Differential to common mode conversion for 40GBASE-R and 100GBASE-R

**Chang Y.F., Wu C.B.
ZTE Corporation
Mar., 2009**

- Proposed modification of Clauses 85 and 86 for high speed serial operation with 40GBASE-R and 100GBASE-R PHYs
- This presentation specially addresses the differential to common mode conversion at transmitter and receiver

Figure 86-8—Mode conversion of mated HCB-MCB

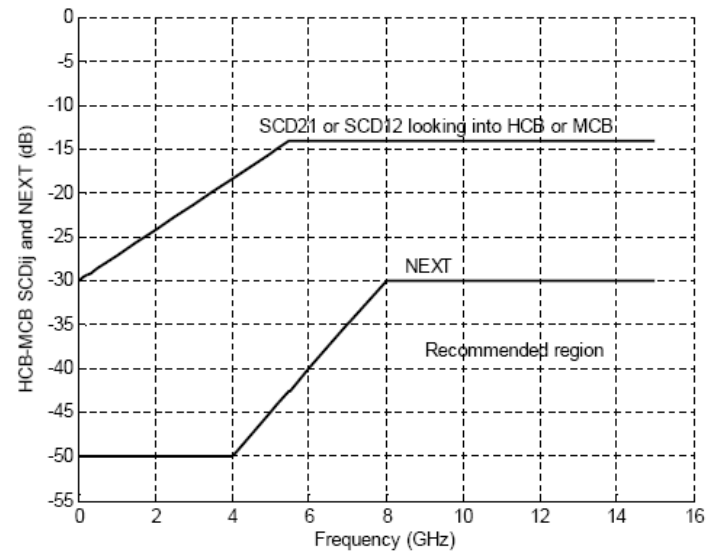
- Computation of differential NEXT and FEXT response is also illuminated in Equations (86-12) and (86-13)
- In 802.3ba D1.2, Figure 86-8 shows the limits of SCD12, SCD21 and NEXT
